**EDWARD B. WALSH & ASSOCIATES, INC.**  
*Complete Civil Engineering Design / Consultation Services*  
Lionville Professional Center  
125 Dowlin Forge Road  
Exton, PA 19341

Re: Preliminary/Final Plan for Cahill subdivision  
Westtown Township  
EBWA No. 4062

The following letter is being written to accompany the resubmission of the above referenced project. We have revised the plans in accordance with the July 11, 2018 letter from McCormick Taylor and the July 17 email from Bill Malin of Carrol Engineering. This letter's enumeration follows that of the consultant's letters.

CONSERVATION  
GRADING & UTILITIES PLAN

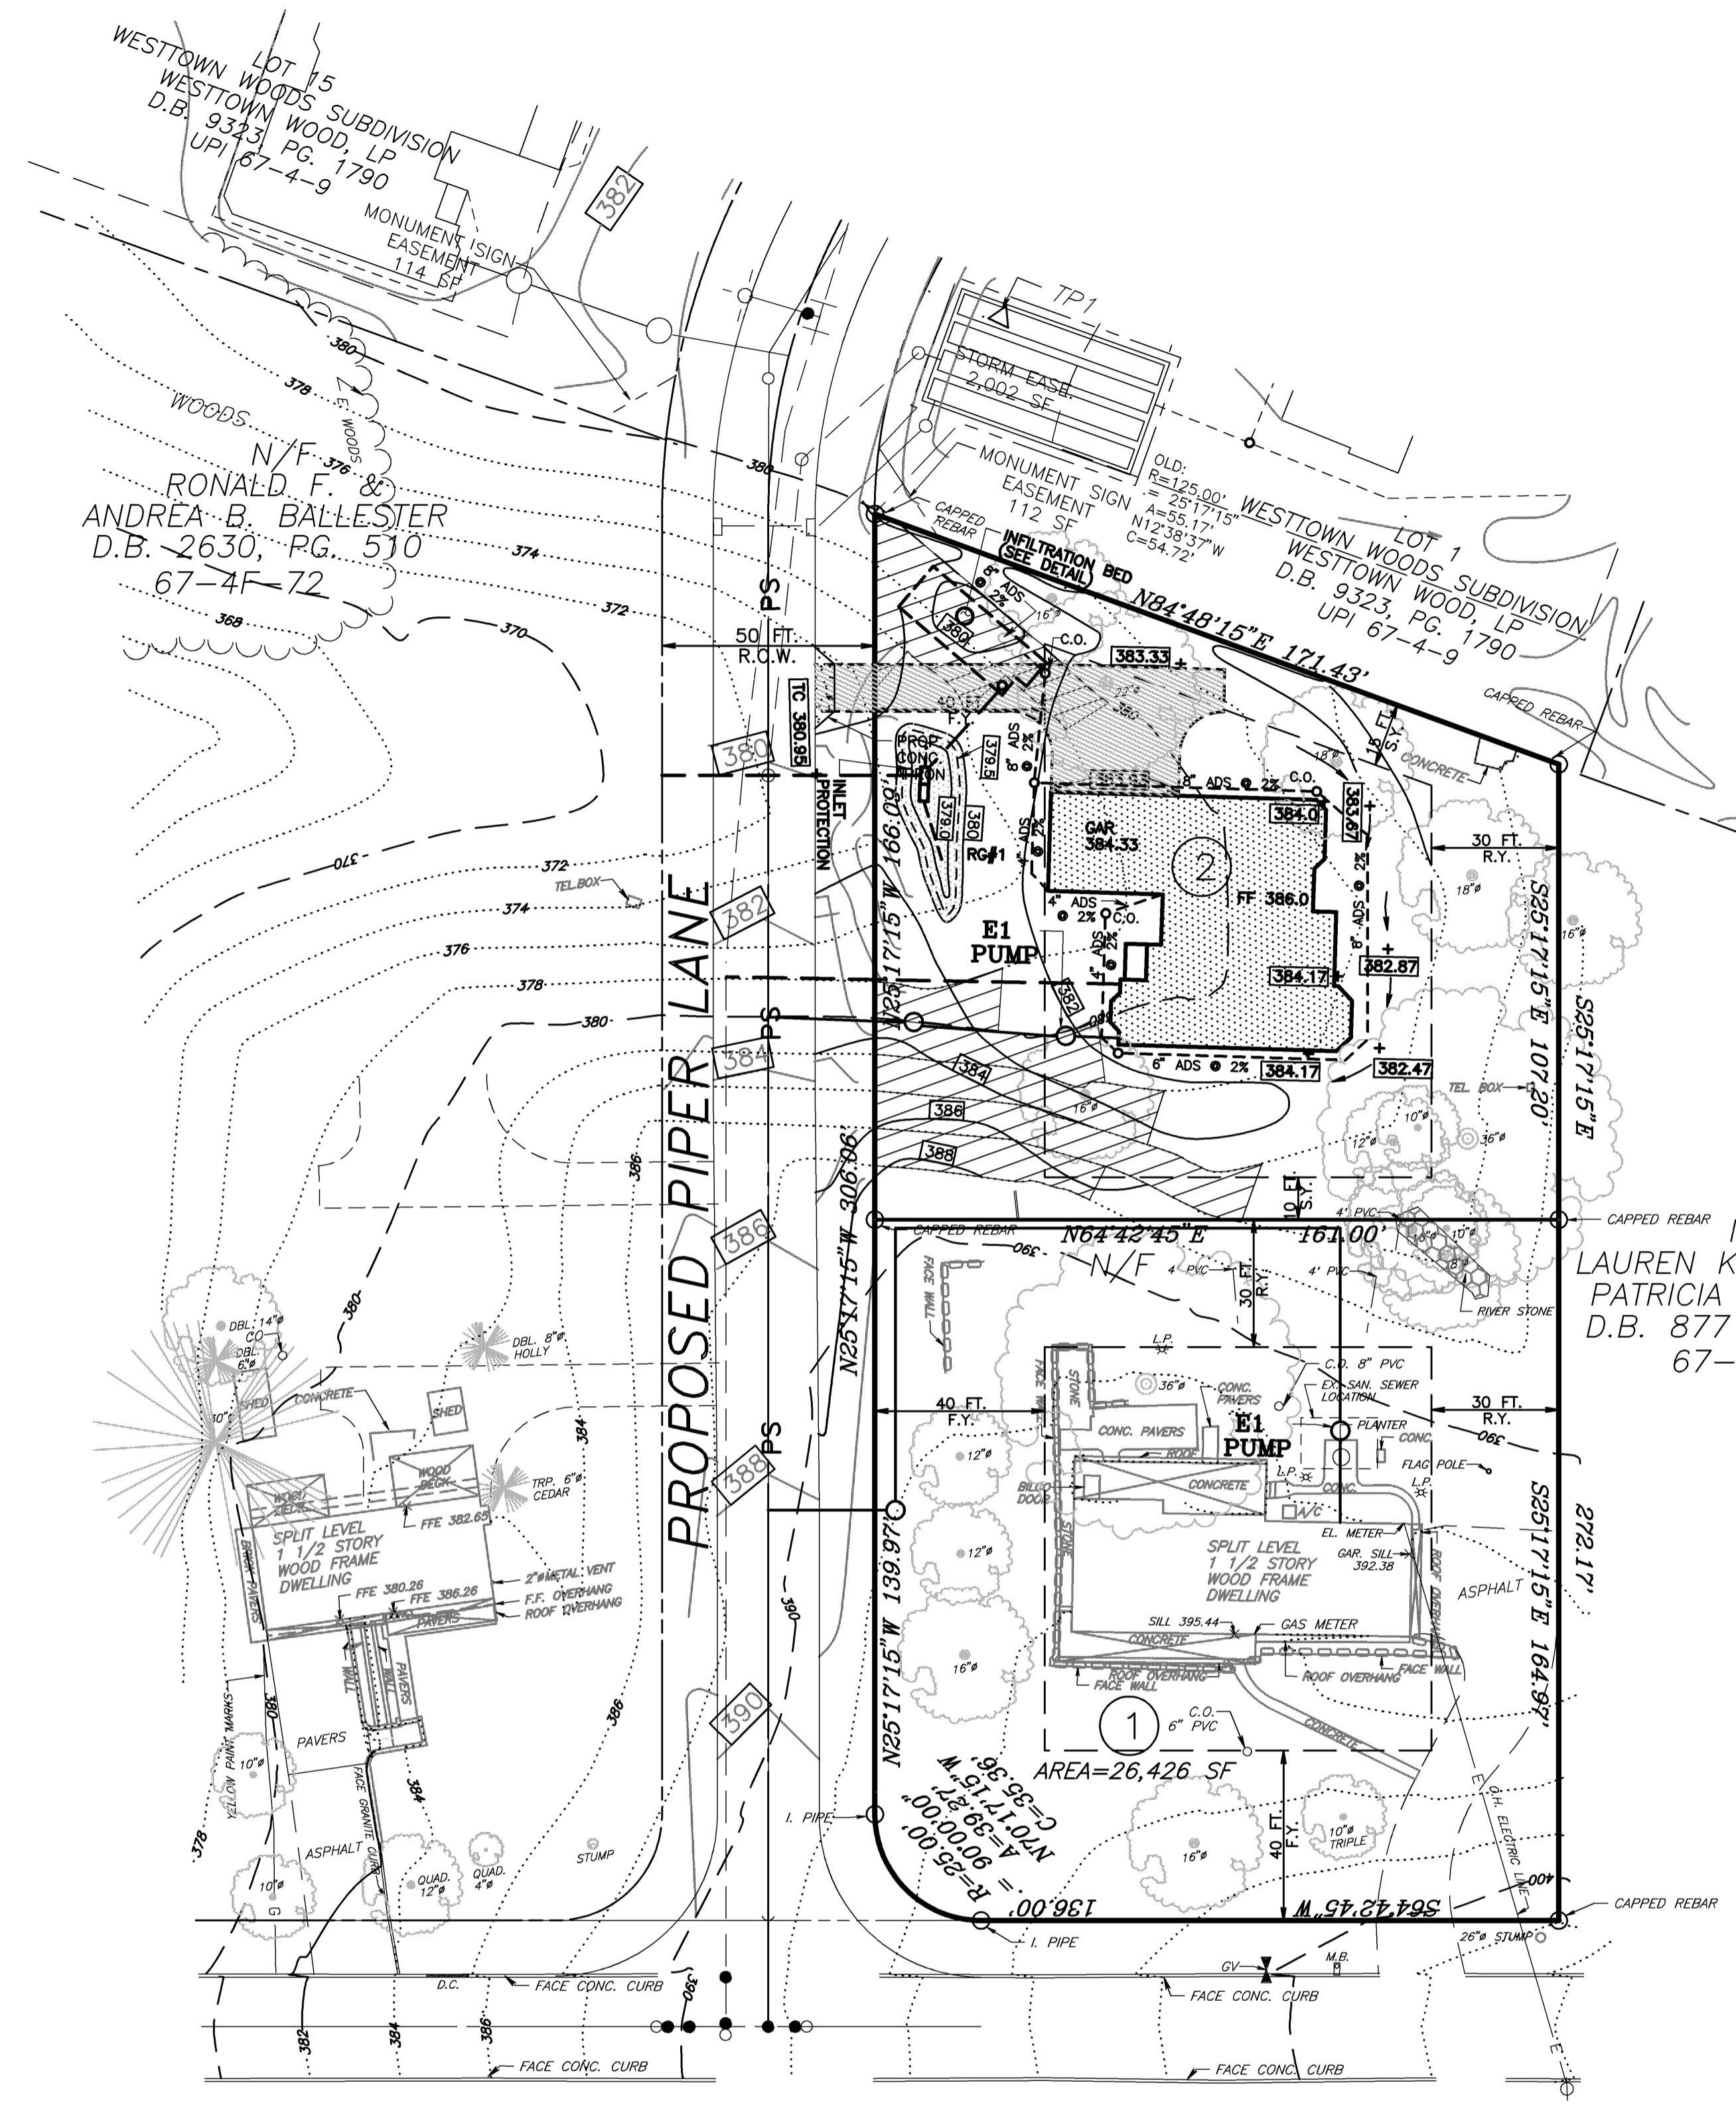
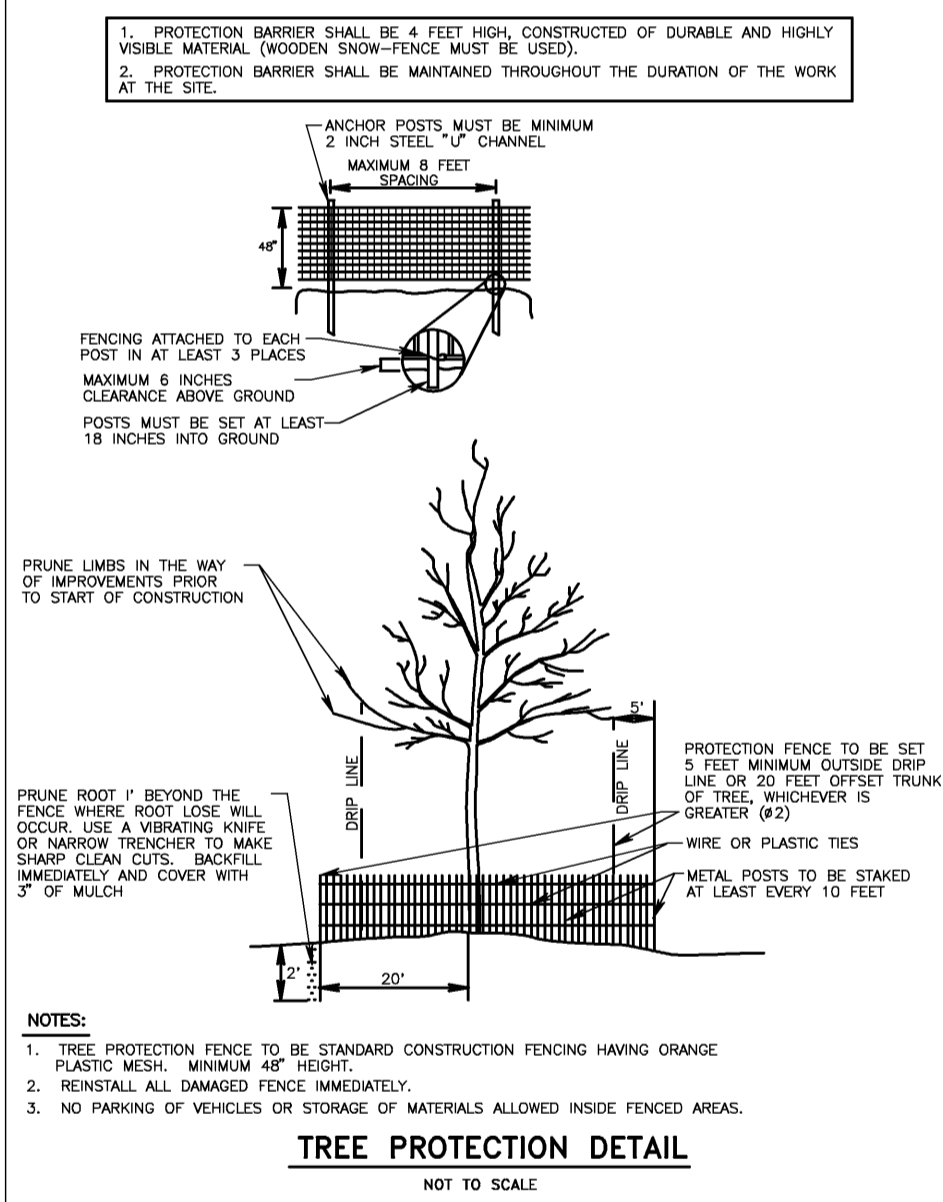
1. We added the location of the existing sewer main to the profile.
2. The Piper Lane profile has not changed so no adjustment is necessary.
